**Narrabri Gas Project (SSD 6456)**  
**Comments on “Submission to IPC following public hearing”**  
**File: “200810 Santos \_Final Submission incl attachments.pdf”**

Dr Bryce Kelly, Ph.D.  
Associate Professor  
School of Biological, Earth and Environmental Sciences  
The University of New South Wales  
21<sup>st</sup> August 2020

### Narrabri Gas Project (SSD 6456) Submission to IPC following public hearing, Section 9.2.1

Figure 1. Images from Iverach et al. (2017) (A, left) and Iverach et al. (2020) (B, right) that show the proximity of the research presented in those two scientific papers to the proposed Narrabri Gas Project.

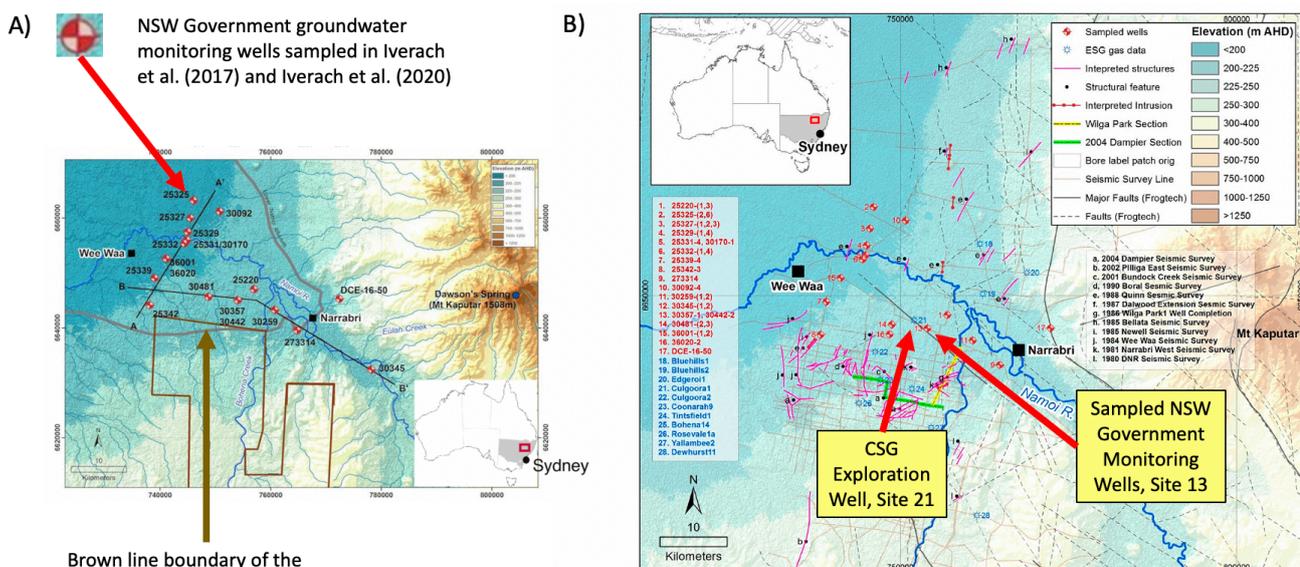
The study by Iverach et al. (2020) is along the nearest margin north of the proposed Narrabri Gas Project and the Namoi Alluvium (Figure 1). In Iverach et al. (2020) groundwater samples were collected from NSW Government groundwater monitoring wells immediately adjacent to the Narrabri Gas Project area and within a few hundred metres of Eastern Star Gas exploration wells (Figure 1). The relationship between the sampled groundwater monitoring wells and the Narrabri Gas Project were shown in Figure 1 of Iverach et al. (2017), and the close proximity of the groundwater monitoring wells sampled to the Eastern Star Gas exploration wells is shown in Figure 1 from Iverach et al. (2020). In Figure 1 below the close proximity between NSW Government groundwater monitoring wells 30357-1, 30442-2 (site 13), and CSG well Culgoora 1 (site 21) is highlighted. In Iverach et al. (2020) a groundwater sample was collected and analysed from the newly installed NSW Government groundwater monitoring well 273314 (depth interval 182 to 195 m below the ground surface). Monitoring well 273314 was installed to provide new information about the regional hydrogeology and in the future to help evaluate whether there are any impacts from coal seam gas developments. The groundwater zone sampled in Iverach et al. (2017 and 2020) is critical for quantifying discharge from the Great Artesian Basin into the Lower Namoi Alluvial Aquifer. Hydrogeological impacts from the proposed Narrabri Gas Project will likely extend beyond the surface boundary of the Narrabri Gas Project in future decades. The submissions to the IPC Narrabri Gas Project (SSD 6456) that cited Iverach et al. (2020) are correct – the research findings in Iverach et al. (2020) do have implications for water management by all sectors in the region, including the Narrabri Gas Project.

The statement by SANTOS that Iverach et al. (2020) is outside the Narrabri Gas Project zone of interest is misleading.

Figure 2. An example well completion report and geological cross-section used in Iverach et al. (2017). Hartogen Wilga Park 1, PEL 238, Gunnedah Basin Appendix C: Wilga Park structural cross section (D001432380).

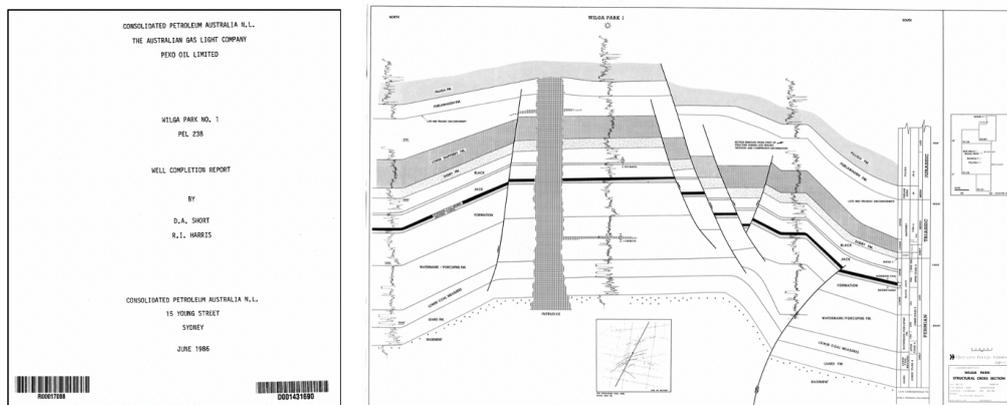
The study by Iverach et al. (2020) does not focus on fault analysis, but this is not important for the results presented in the paper. The study by Iverach et al. (2020) is a hydrogeochemical study focusing on the Lower Namoi Alluvial Aquifer. In Iverach et al. (2020) it is stated that the pathway of methane migration from depth is not known, and that the methane migration could be via *other geological pathways*. SANTOS's focus on faults as the only pathway of methane migration is misleading. Further research is required by all to understand when and how the methane has migrated from the geological formations beneath the NSW Government groundwater monitoring wells sampled in Iverach et al. (2020). In Iverach et al. (2020) both Figure 1 and supplementary information Figure 1 show a collation of fault data that had been mapped by others. Various oil and gas companies did the fault interpretation, not the authors of Iverach et al. (2020). For example, shown in supplementary information Figure 1 (Iverach et al. 2020) is the section from the well completion report by Consolidated Petroleum Australia N.L., The Australian Gas Light Company, Peko Oil Limited (Figure 2). All the past reports are available in the DIGS database (<https://search.geoscience.nsw.gov.au>). The fault summary presented in Figure 1 in Iverach et al. (2020) is simply to show visually that there are many faults in the region, because faults may or may not have an influence on regional groundwater flow paths and the hydrogeochemistry. SANTOS in their EIS present a similar stylised presentation of the faulting in the region in their EIS submission "Appendix F Groundwater Impact Assessment Figure 4-11".

Submissions to the IPC Narrabri Gas Project (SSD 6456) that made reference to methane migration via faults, or hydraulic pressure transfer via faults cannot be dismissed until SANTOS provides detailed evidence in the public domain about their fault seal analysis, including Allan diagrams, fragmentation studies, capillary pressure diagrams and more (Cervený et al. 2004). Data for a statistically valid number of faults needs to be presented.

Figure 2. A map from Herczeg et al. (1991) showing that they sampled the Great Artesian Basin far from the region of interest for the Narrabri Gas Project.

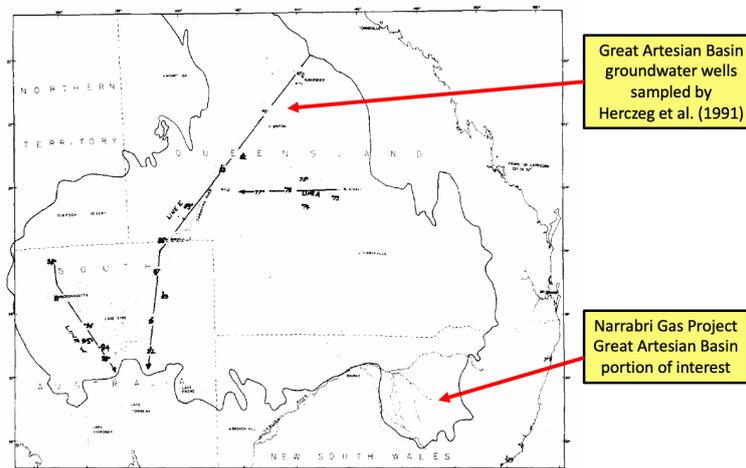
When preparing Iverach et al. (2020) an extensive search was undertaken for all available data in the public domain from the NSW DIGS database (<https://search.geoscience.nsw.gov.au>), and that is presented in supplementary information Table 1.b Iverach et al. (2020). SANTOS did not cite any references from their own reports with data to make a case against Iverach et al. (2020), nor did SANTOS provide any data from “Herzeg & Torgeson, (1991)” or “DMR (2002)”. It is difficult to check the relevance of these documents because SANTOS did not provide complete reference details for “Herzeg & Torgeson, (1991)” or “DMR (2002)”. A check in the scientific journal database Scopus does not locate a paper by “Herzeg & Torgeson, 1991”; Herczeg and Torgerson (note the spellings of the names) did publish research on the Great Artesian Basin in 1991 (Herczeg et al. 1991), but this was for groundwater wells in South Australia through to central Queensland. If this is the paper SANTOS intended to cite it is outside the area of interest by hundreds of kilometres (Figure 2).

SANTOS cited two references and did not provide comprehensive reference details for either. The first reference, “Herzeg and Torgenson 1991”, is likely to be Herczeg et al. (1991), which is a Great Artesian Basin (GAB) study that extends from central South Australia through to central Queensland. This is in the wrong portion of the GAB and is not relevant. The second reference, “DMR 2002”, likely to be NSW DMR (2002) has no useable hydrogeochemical data to extend the work in Iverach et al. (2020). SANTOS had an opportunity to provide their own data – they did not.

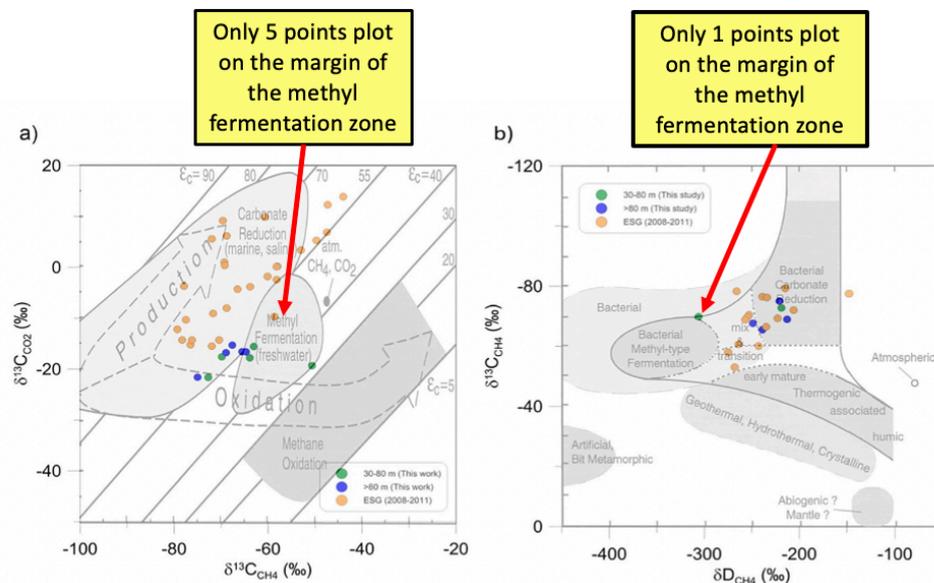
Iverach et al. (2020) does not say there is no methyl fermentation, however it can only be a minor process in the Namoi Alluvium. Data from supplementary information Tables 1.a and 1.b (Iverach et al. 2020) are used in Figure 7 (Figure 4 of this document) to examine methane production and oxidation pathways. The data from Table 1.a are from the sampled NSW Government groundwater monitoring wells and the data from Table 1.b are from Eastern Star Gas well completion reports. These data are presented on  $\delta^{13}\text{C}_{\text{CO}_2}$  vs  $\delta^{13}\text{C}_{\text{CH}_4}$  and  $\delta^{13}\text{C}_{\text{CH}_4}$  vs  $\delta\text{D}_{\text{CH}_4}$  plots (Figure 4). These graphs from Whiticar (1999) are frequently used to determine methane production and oxidation pathways (Whiticar 1999 has been cited over 2300 times).

SANTOS do not provide a graph of any data to support the claim that methyl fermentation is a significant active process within the Lower Namoi Alluvial Aquifer or any geological formation. Iverach et al. (2020) present multiple lines of evidence including comprehensive hydrogeochemistry data, methane isotope chemistry data and a microbial community composition and abundance analysis to support the methane oxidation model in the paper. These multiple lines of evidence also show that conditions within the Lower Namoi Alluvial Aquifer are far from optimal for methyl fermentation to be a dominant process. The abundance of methanotrophic bacteria shown in Iverach et al. (2020) Figure 3 suggested that oxidation is a significant process. In addition, the dissolved oxygen levels are in general not anaerobic enough for methanogenesis.

SANTOS provide no evidence that methyl fermentation is a dominant process in the Lower Namoi Alluvium. Iverach et al. (2020) provide multiple lines of evidence that methyl fermentation is not a significant process in the Lower Namoi Alluvial Aquifer. The methane oxidation model proposed in Iverach et al. (2020) is supported by data and the Rayleigh fractionation modelling.
